**ZONING CHANGE REVIEW SHEET**CASE: C14-2022-0156DISTRICT: 1ADDRESS: 10711 Decker LaneZONING FROM: I-RRTO: CS-MUSITE AREA: 99.72 acres (4,242,803.20 sq. ft.)PROPERTY OWNER: Heart of Manor LPAGENT: Kimley-Horn (Ethan Harwell)CASE MANAGER: Jonathan Tomko (512-974-1057, [jonathan.tomko@austintexas.gov](mailto:jonathan.tomko@austintexas.gov))STAFF RECOMMEDATION: Staff recommends CS-MU zoningPLANNING COMMISSION or ZONING AND PLATTING COMMISSION ACTION /  
RECOMMENDATION:

**Project Name and Proposed Use:** 10711 DECKER LANE. C14-2022-0156. Project: Webb Tract Rezoning. 99.72 acres from I-RR to CS-MU. Proposal: Mixed-use commercial and residential development. Nov 9, 2022

**Date:** March 28, 2023  
**To:** Santiago Araque, P.E., Kimley-Horn and Associates. Inc.  
**CC:** Bryan Golden, Maria Cardenas, Austin Transportation Department  
**Reference:** Transportation Impact Analysis Final Memo  
Webb Tract - C14-2022-0156

**Exhibit A***Figure 1 Site Location**Figure 2 Location of the Improvements**Figure 3 Braker Lane Cross-section*

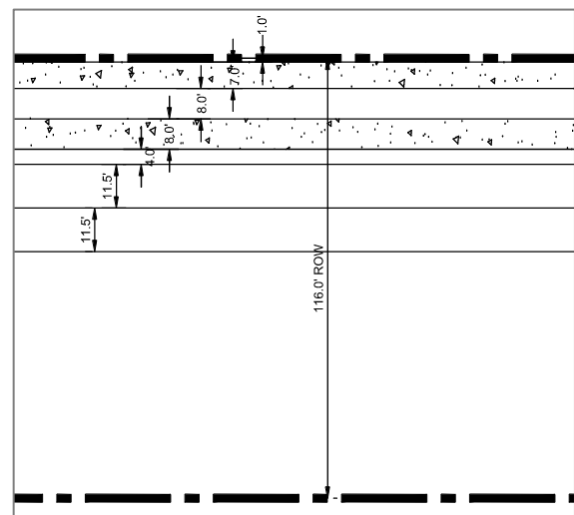
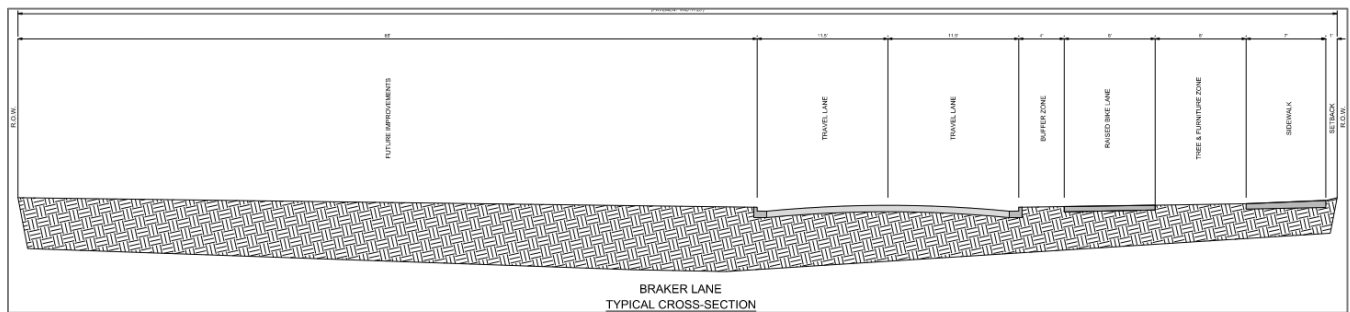
2. The applicant shall design, and construct improvements identified in Table 2 below prior to the issuance of the temporary certificate of occupancy (TCO) or certificate of occupancy (CO). Cost estimates should not be assumed to represent the maximum dollar value of improvements the applicant may be required to construct.

Name	Improvement	Cost	Developer's Share
Braker Lane Extension (See Exhibit A for the improvement extent)	Design and construct half of Braker Lane's cross-section per ASMP per COA standards within the property boundary	\$1,969,679	100%
